# McInroe Consulting

### Example Interactive Document Set

### ARCHITECT'S DIRECTIVE

**SKA-01**

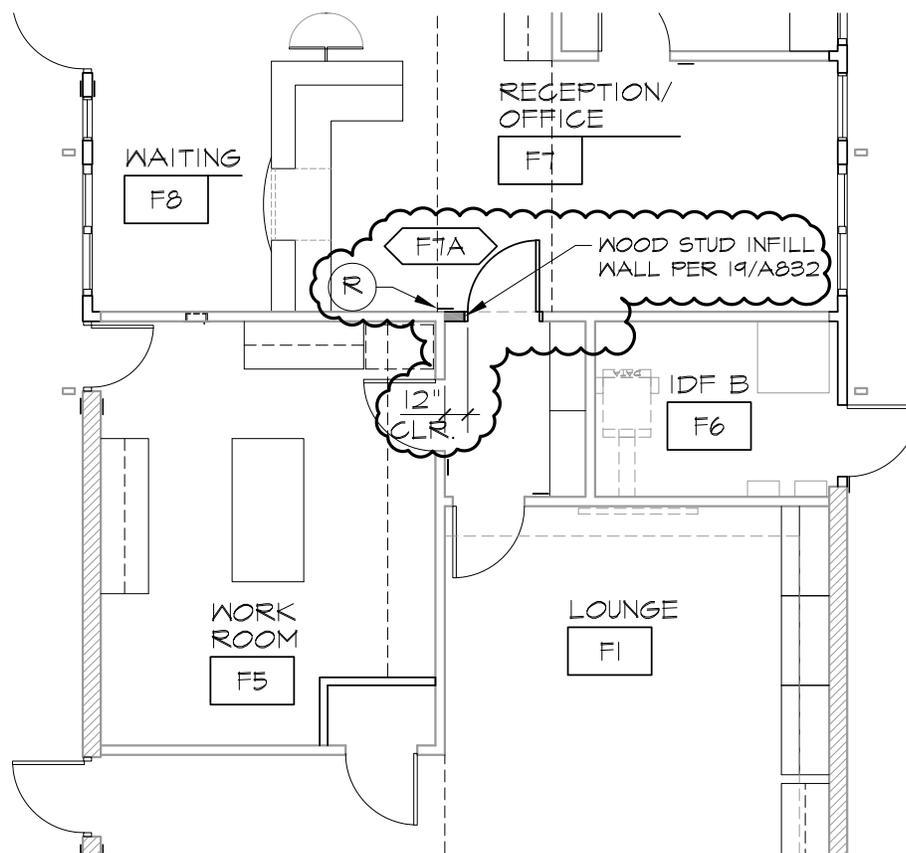
Provide new door and doorframe complete at the location shown on the attached sketch SKA-01.

# BLDG. 'F' - FLOOR PLAN

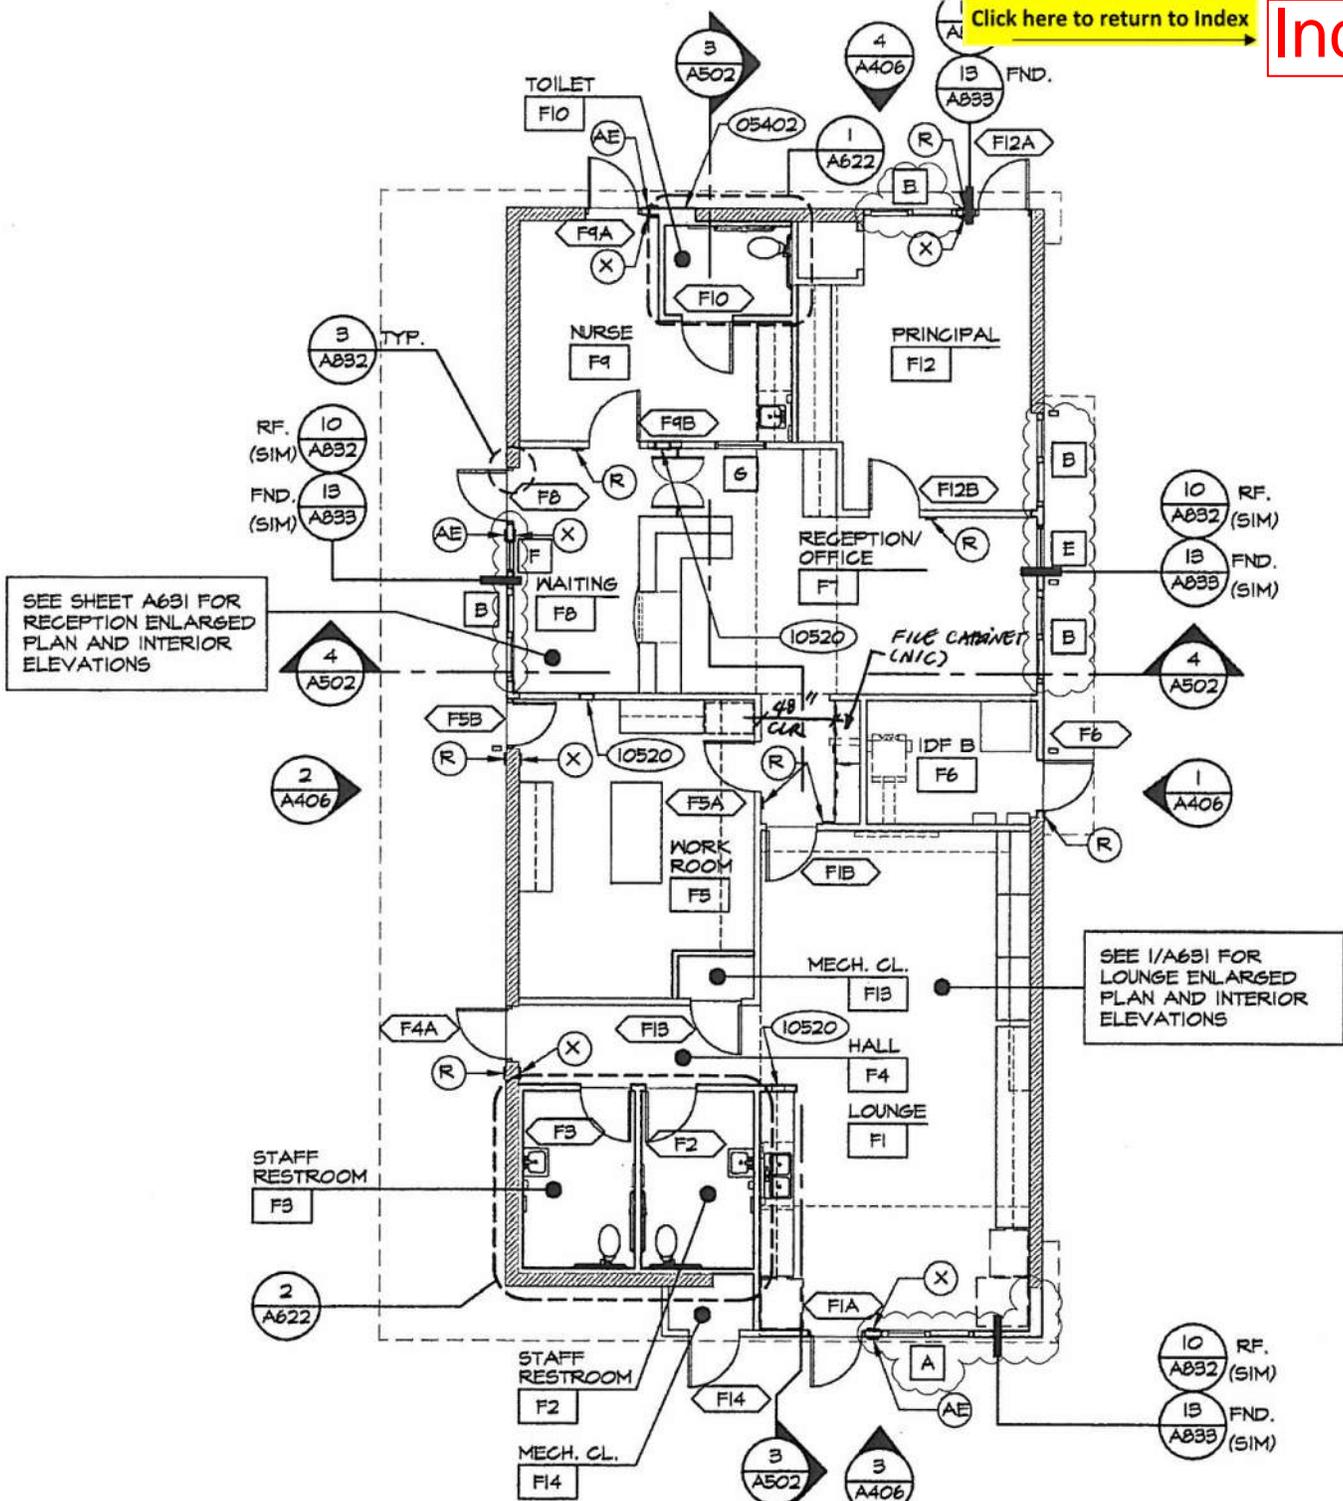
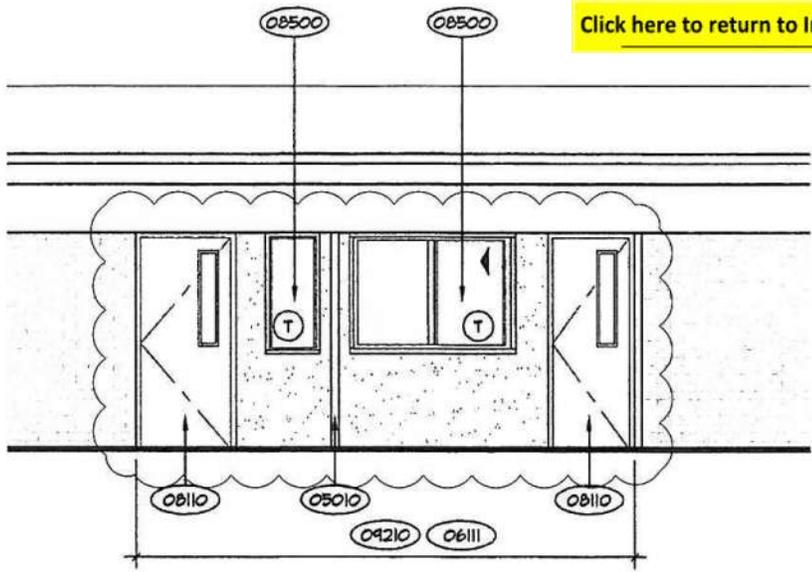
Provide new windows and stucco walls at the Administration Building per the attached sketches. Due to the scheduling constraints, I believe that hollow metal window frames were acceptable in lieu of the specified aluminum windows.

### BLDG. F - RECEPTION OFFICE

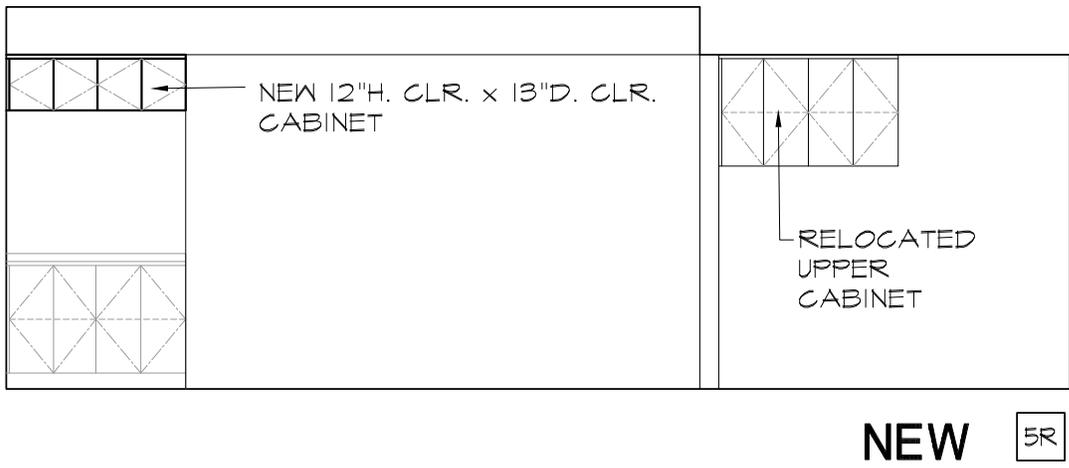
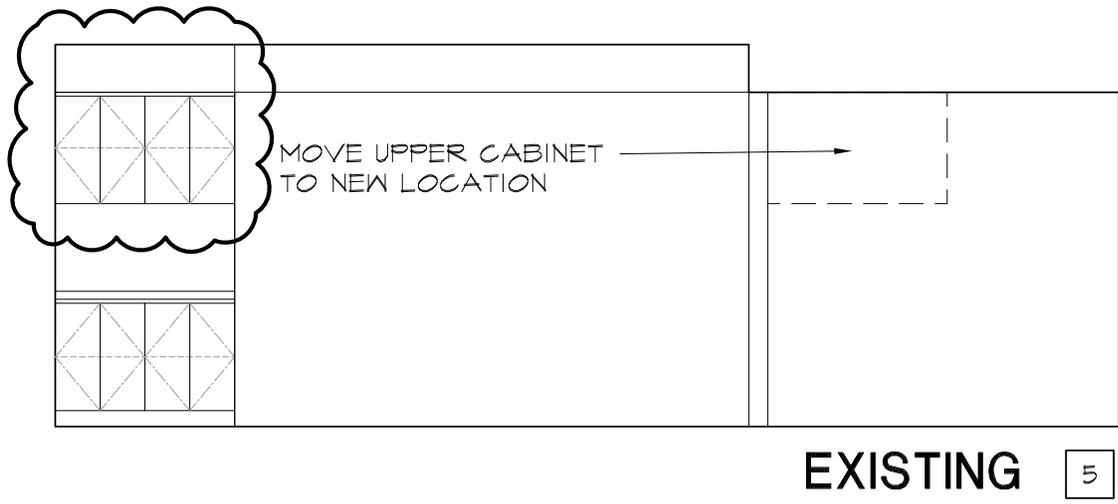
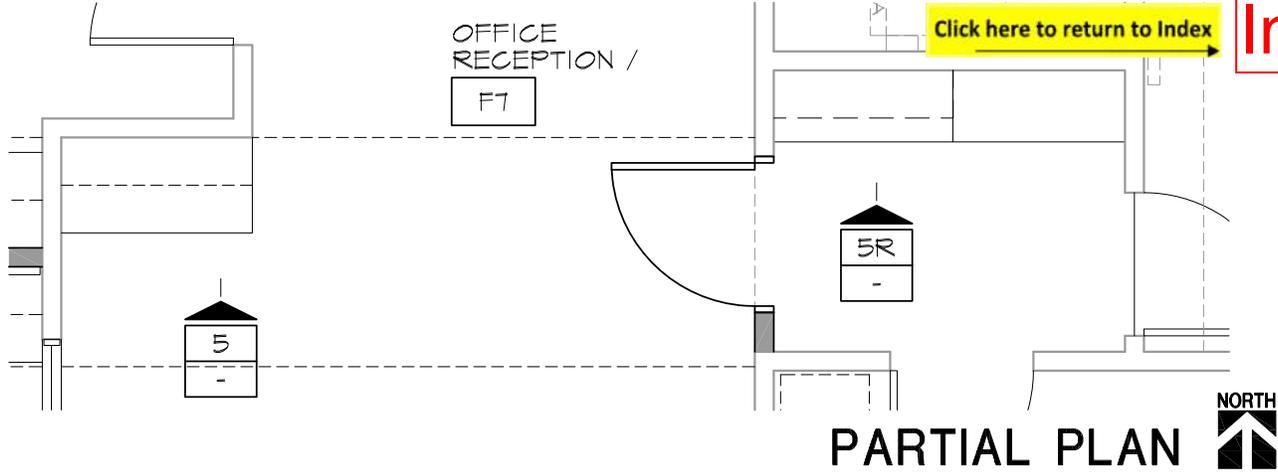
Please provide the following in the Administration Area:

1. Relocate an existing upper cabinet as indicated on attached sketch SKA-01.
2. Install new upper cabinet as indicated on attached sketch SKA-01.

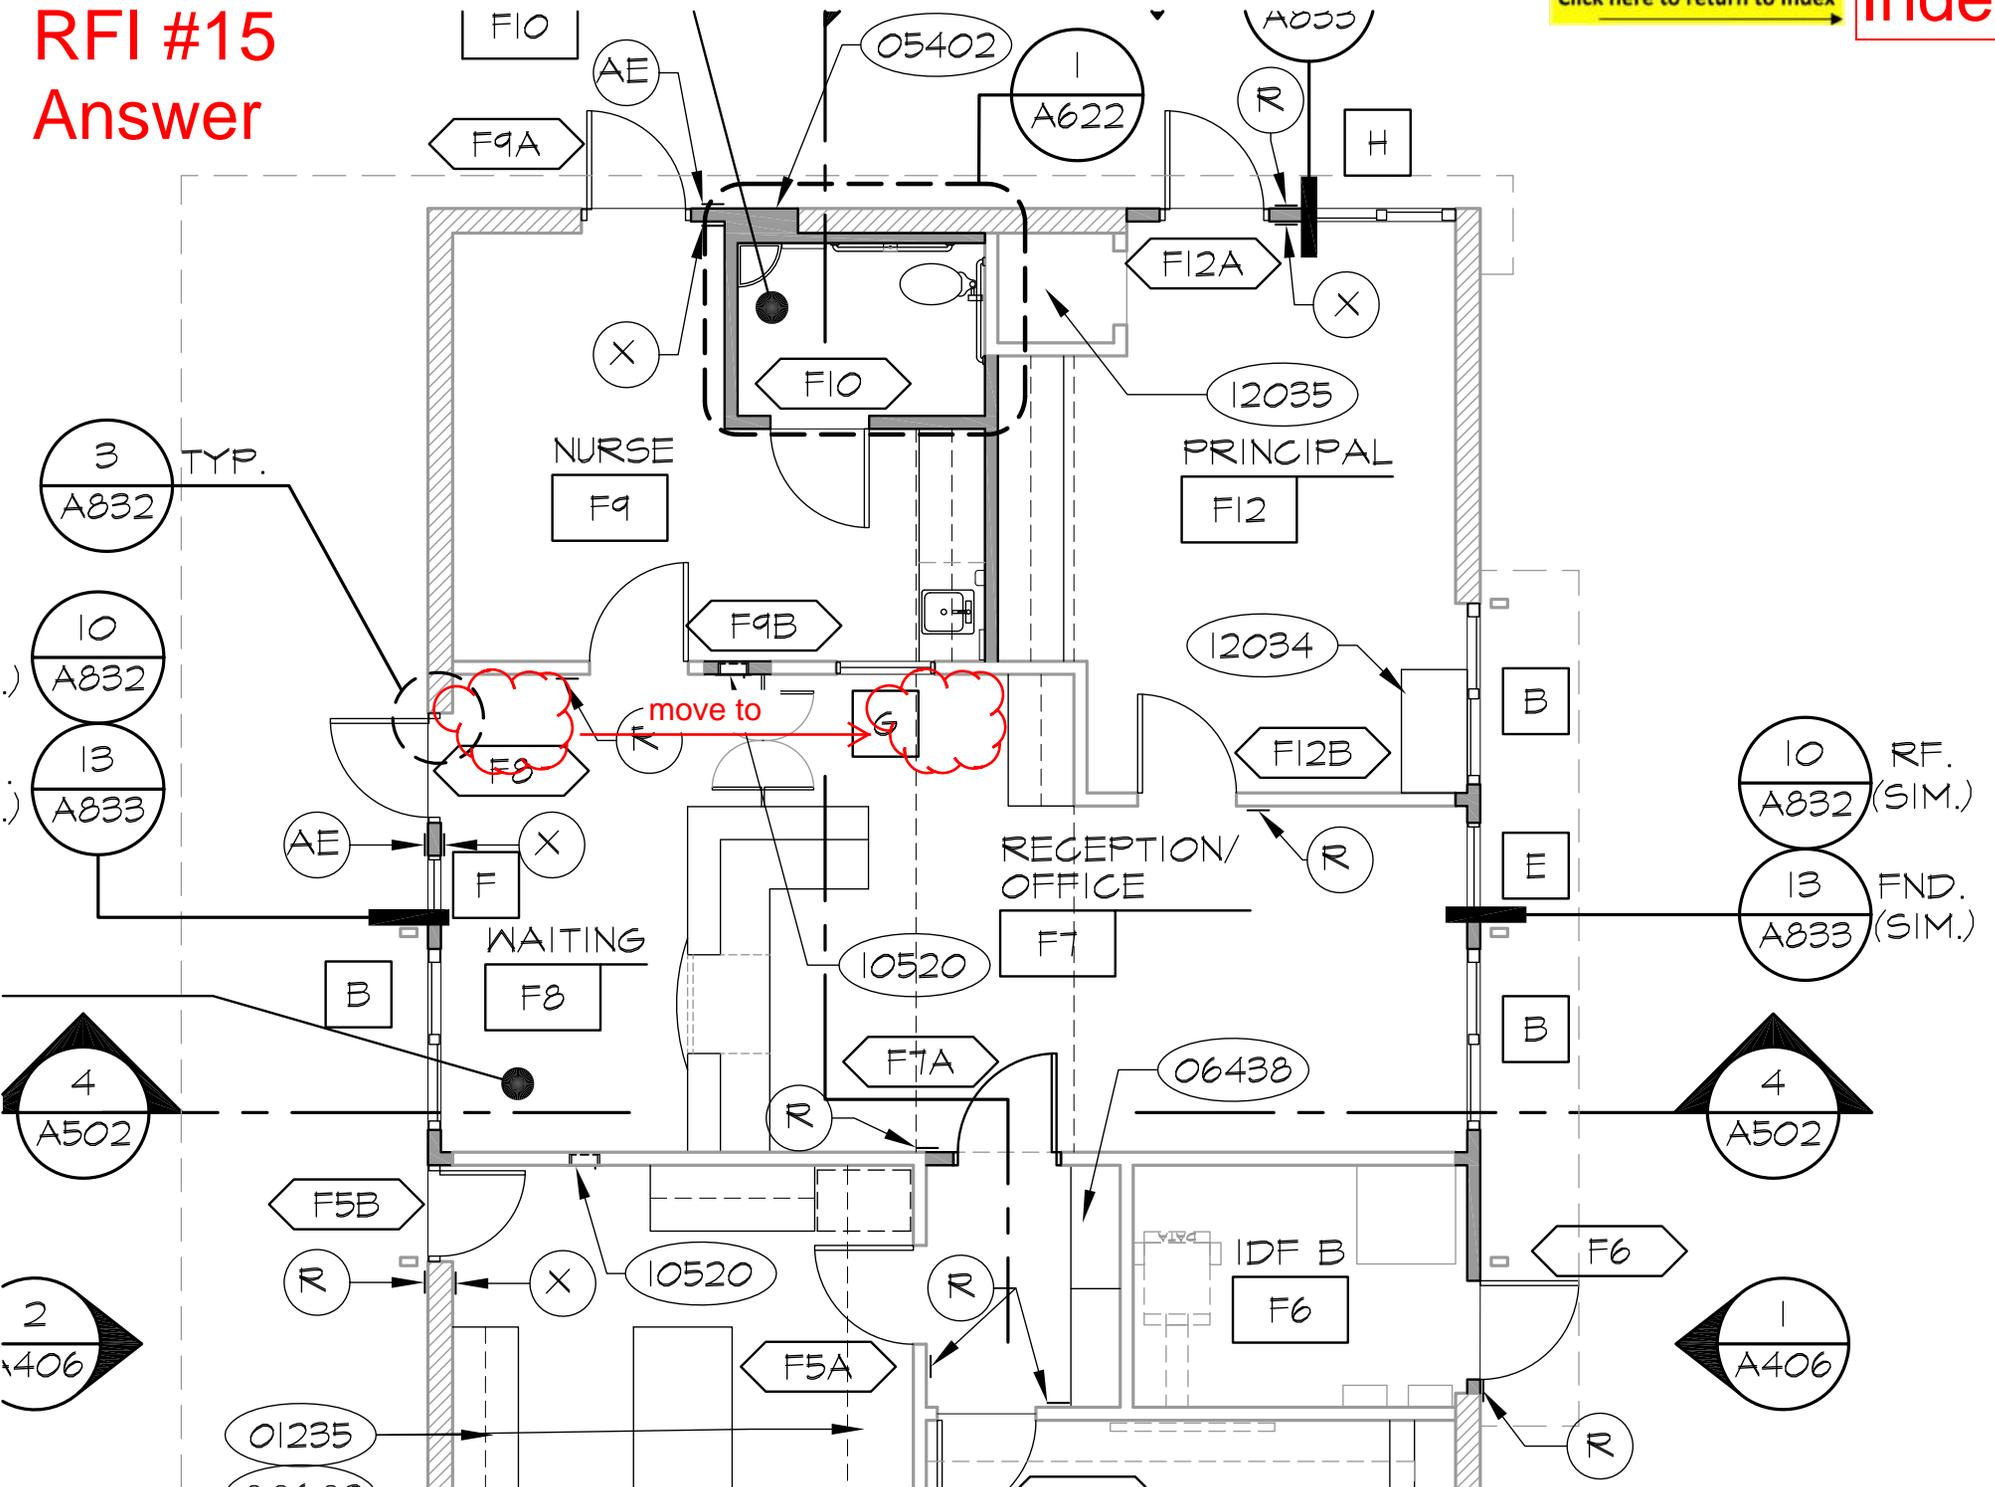
Please relocate the Fire Remote Annunciator devices from its present location in the Administration Waiting Area to inside the Reception/Office Area on the same wall per attached sketch.

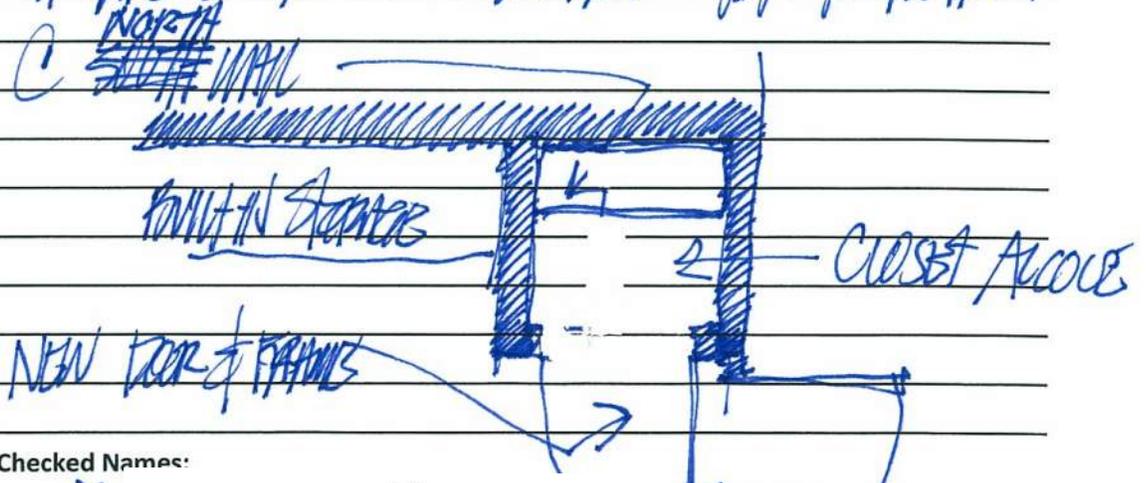
ADMINISTRATION BUILDING - PRINCIPAL'S OFFICE  
 REQUIRES HOLLOW METAL FRAME w/ DOOR @  
 CLOSET ACCESS.

PROVIDE & INSTALL ADJUSTABLE KEYS  
 STEERING @ 12" O.C. VERTICAL TOP TO PLATFORM
